COCONUT POINT MPD/DRI (Tract 1D-3)

Mixed Use Planned Development Amendment Zoning Staff Report

HILTON GARDEN INN ON TRACT 1D-3

DCI2017 - E003

HILTON GARDEN INN ESTERO, FL. DEVIATION 1 & 2 BUILDING HEIGHT

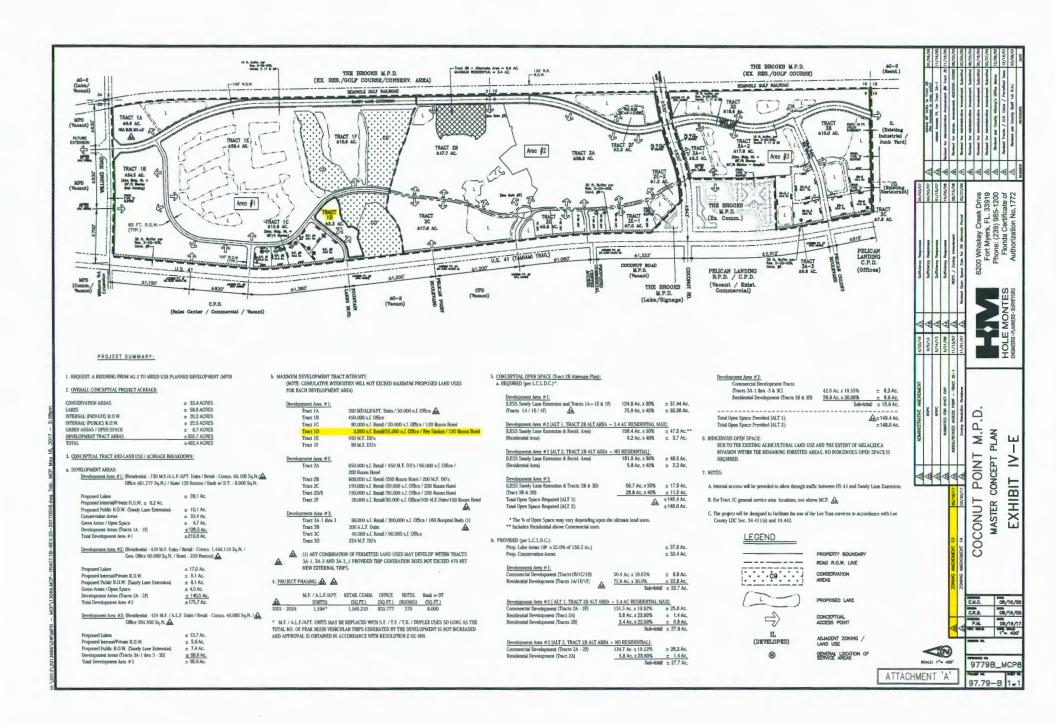
- DEVIATION I SEEKS RELIEF FROM THE LDC SECTION 33-229, MAXIMUM HEIGHT, WHICH LIMITS MAXIMUM BUILDING HEIGHT OUTSIDE OF THE INTERSTATE HIGHWAY INTERCHANGE AREAS TO A MAXIMUM OF THREE STORIES OR 45 FEET, TO ALLOW A MAXIMUM BUILDING HEIGHT OF 55 FEET, MEASURED PER SEC. 34-2171 (1) OF THE LAND DEVELOPMENT CODE.
- DEVIATION 2 SEEKS RELIEF FROM LDC SECTION 33-229, MAXIMUM HEIGHT, WHICH REQUIRES A DEVIATION TO EXCEED THE MAXIMUM HEIGHT LIMITATIONS FOR ARCHITECTURAL ELEMENTS THAT ENHANCE VISIBILITY, OR CREATE FOCAL POINTS OR AMENITIES, SUCH AS TURRETS, SCULPTURE, CLOCK TOWER AND CORNER ACCENTUATING ROOFLINES, TO ALLOW FOR ARCHITECTURAL ELEMENTS NOT TO EXCEED AN ADDITIONAL 22 FEET IN HEIGHT.

45-feet, to allow a maximum building height of 55 feet, as measured in accordance with LDC Section 34-2171(1). **Approved** as depicted in the Pattern Book.

Deviation 2 is from LDC Section 33-229, "Maximum Height," which requires a deviation to exceed the maximum height limitations for architectural elements that enhance visibility or create focal points or amenities, such as turrets, sculpture, clock tower, and corner accentuating rooflines, to allow for architectural elements not to exceed an additional 22 feet in height for a maximum architecture feature height of 77 feet as depicted in the Pattern Book. **Approved** as depicted in the Pattern Book.
